Access Compliance Report Public Rights-of-Way (Curb Ramps)

Main Street: ESENCIA_DR Cross Street: COW_CAMP_RD Location: E

ADA ID: RPRK211129121216 Ramp Type: Type 1 - Perpendicular Diagonal Initial Pass/Fail: Fail Overall Compliance: No Severity Score: 16

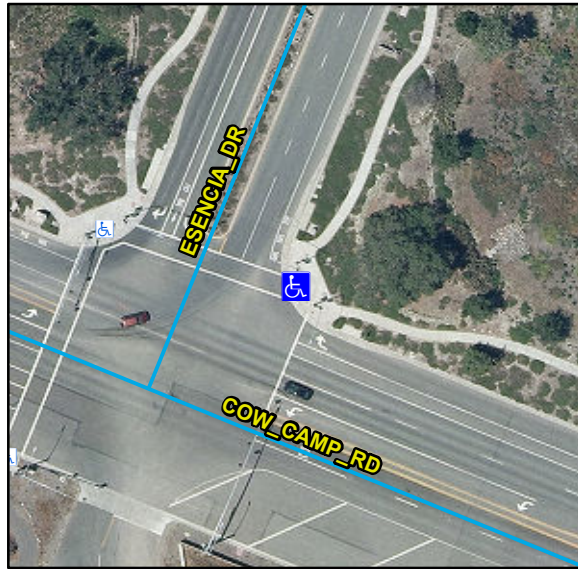
Compliance	Description	Data	Compliance	Description	Data
N/A	Ramp Length (in)	128	N/A	Flare Type LT	
Yes	Ramp Width (in)	48			N/A
No	Ramp Run Slope (%)	8.5	N/A	Flare Slope LT (%)	N/A
Yes	Ramp Cross Slope (%)	1.6	N/A	Flare Traversable LT	N/A
N/A	Landing Present	N/A	N/A	Flare Type RT	
N/A	Landing Length (in)	N/A			N/A
N/A	Landing Width (in)	N/A	N/A	Flare Slope RT (%)	N/A
N/A	Landing Run Slope (%)	N/A	N/A	Flare Traversable RT	N/A
N/A	Landing Cross Slope (%)	N/A	N/A	DWS Provided	N/A
N/A	Landing Movement Obstructed?	N/A	N/A	DWS Contrast	N/A
	Landing Movement Type	N/A	N/A	DWS Length (in)	N/A
N/A	Landing Shared	N/A	N/A	DWS Full Width	N/A
N/A	Clear Space	Yes	N/A	DWS Offset Left (in)	N/A
N/A	Clear Space To Crosswalk (in)	N/A	N/A	DWS Offset Right (in)	N/A
N/A	Marked Crosswalk 1	Yes	N/A	Marked Crosswalk 2	No
	Crossing 1 Direction	NW		Crossing 2 Direction	S
	Marked Crosswalk 1 Width (in)	144		Marked Crosswalk 2 Width (in)	N/A

Remove & Replace Curb Ramp With Two New Directional Ramps or Equivalent.

R304.2.2, STD 1115
